**Final
Environmental Impact Report
for
Magee Ranches**

State Clearinghouse File: 2010112042
Town Files: LEG10-0004, SD9291 & DEV10-0072

April 2013

Prepared by:
DENISE DUFFY & ASSOCIATES, INC.
Environmental Planning & Consulting
947 Cass Street, Suite 5
Monterey, CA 93940

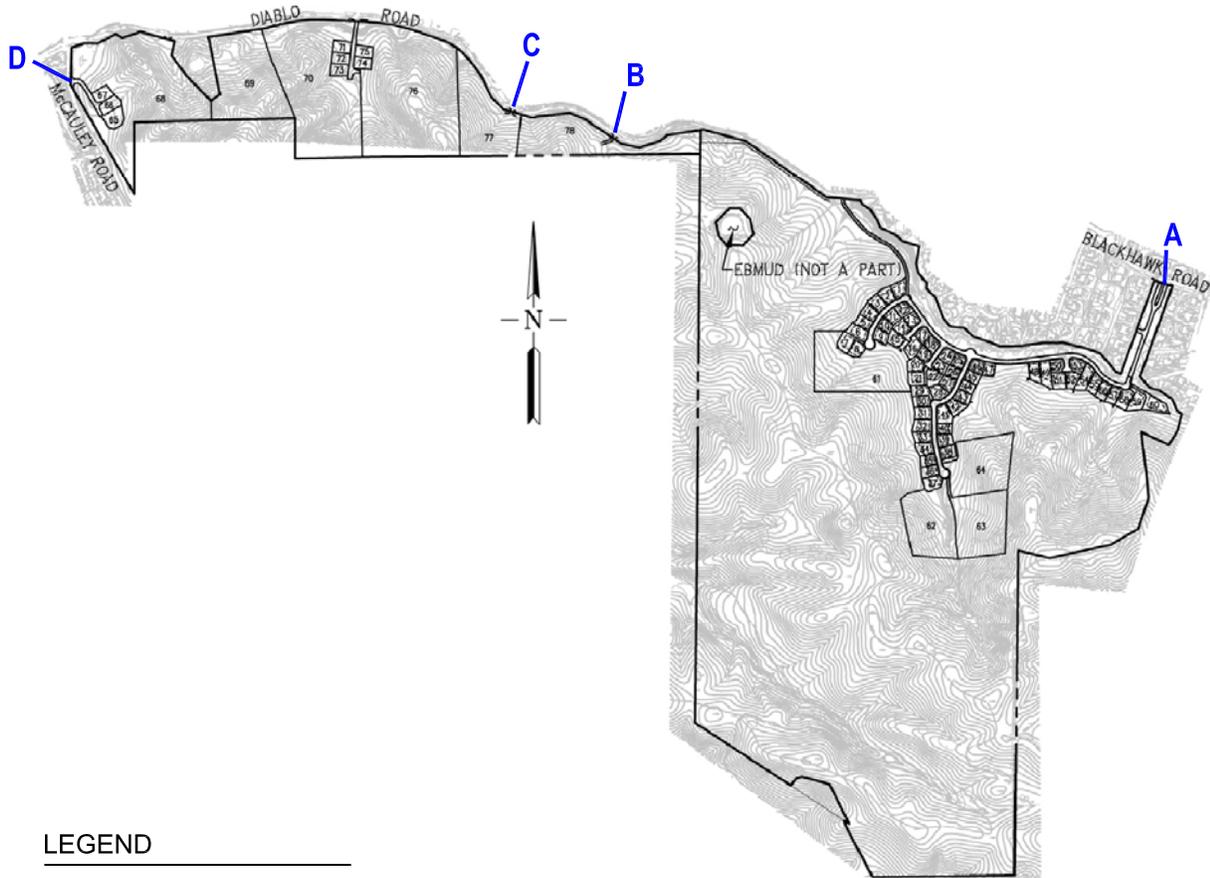
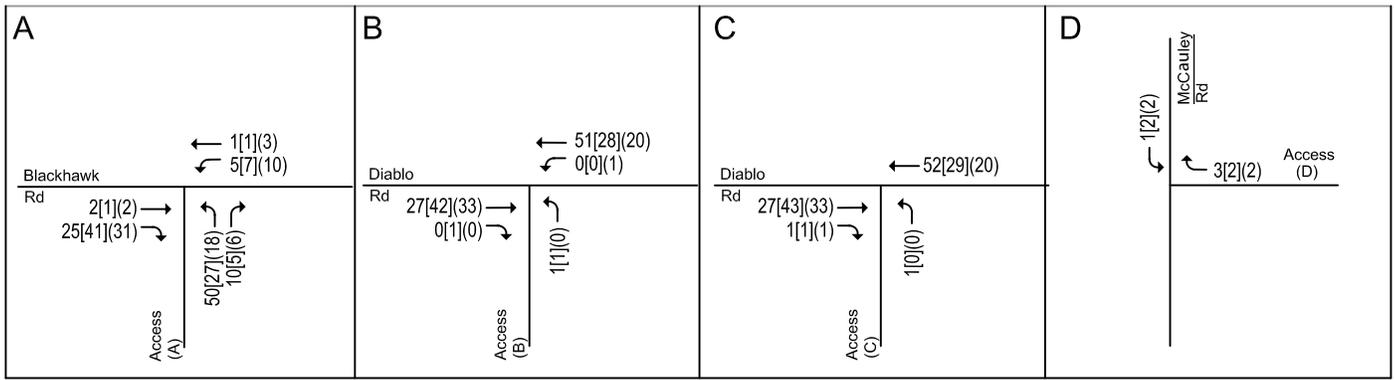
S8E Comment: The Draft EIR should also go through and check, they occasionally use the word McClosky or McClauley, particularly on drawing 4.12-8, I think you meant to use McCauley Road.

Page 4.12-23, Figure 4.12-8 is revised to correct the spelling from McCowley to McCauley Road at driveway D, as shown on the following pages.
